Access Compliance Report Public Rights-of-Way (Curb Ramps)

Main Street: RAINBOW_DR Cross Street: RED_HILL_AVE Location: SW

ADA ID: RPAT211021140740 Ramp Type: Type 1 - Perpendicular Diagonal Initial Pass/Fail: Pass Overall Compliance: No Severity Score: 19

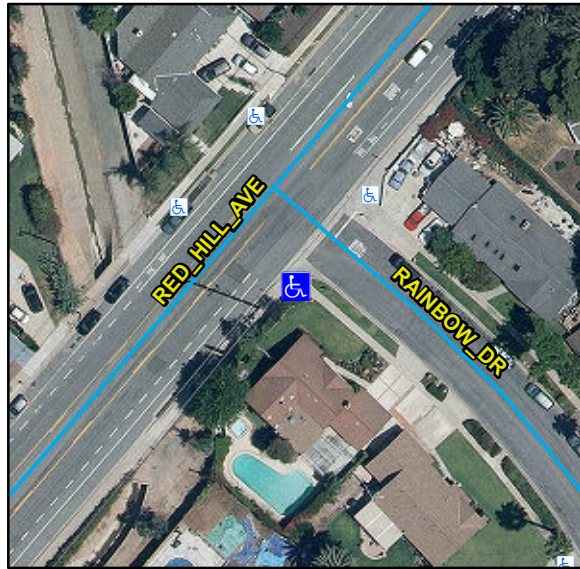
Compliance	Description	Data	Compliance	Description	Data
N/A	Ramp Length (in)	64	N/A	Flare Type LT	
Yes	Ramp Width (in)	49			Sloped
Yes	Ramp Run Slope (%)	7	N/A	Flare Slope LT (%)	7.5
Yes	Ramp Cross Slope (%)	1.3	N/A	Flare Traversable LT	No
N/A	Landing Present	Yes	N/A	Flare Type RT	
N/A	Landing Length (in)	36			Sloped
Yes	Landing Width (in)	48	N/A	Flare Slope RT (%)	8.2
No	Landing Run Slope (%)	5.4	N/A	Flare Traversable RT	No
No	Landing Cross Slope (%)	2.8	No	DWS Provided	No
N/A	Landing Movement Obstructed?	Yes	N/A	DWS Contrast	N/A
	Landing Movement Type	Curb	N/A	DWS Length (in)	N/A
N/A	Landing Shared	No	N/A	DWS Full Width	N/A
N/A	Clear Space	Yes	N/A	DWS Offset Left (in)	N/A
N/A	Clear Space To Crosswalk (in)	48	N/A	DWS Offset Right (in)	N/A
N/A	Marked Crosswalk 1	No	N/A	Marked Crosswalk 2	No
	Crossing 1 Direction	NE		Crossing 2 Direction	NW
	Marked Crosswalk 1 Width (in)	N/A		Marked Crosswalk 2 Width (in)	N/A

N/A	Ramp Inside Crosswalk 1	N/A	Yes	Ramp Inside Crosswalk 2	N/A
	Crossing 1 Slope (%)	4		Crossing 2 Slope (%)	3.7
	Crossing 1 Cross Slope (%)	3.1		Crossing 2 Cross Slope (%)	0.6
Yes	Gutter Ponding	No	Yes	Curb Slope	7
Yes	Gutter Lip Height (in)	0		Road Run Slope (%)	3
Yes	Gutter Run Slope (%)	3.5		Road Cross Slope (%)	3.8
Yes	Gutter Cross Slope (%)	2			
Yes	Overall Surface Condition: Acceptable		No	Perp Joint Present	No
	Cross Gutter Present?	Yes		Spandrel Present?	Yes
	Replace Cross Gutter?	No		Replace Spandrel?	No

Remove & Replace Curb Ramp With Two New Directional Ramps or Equivalent.
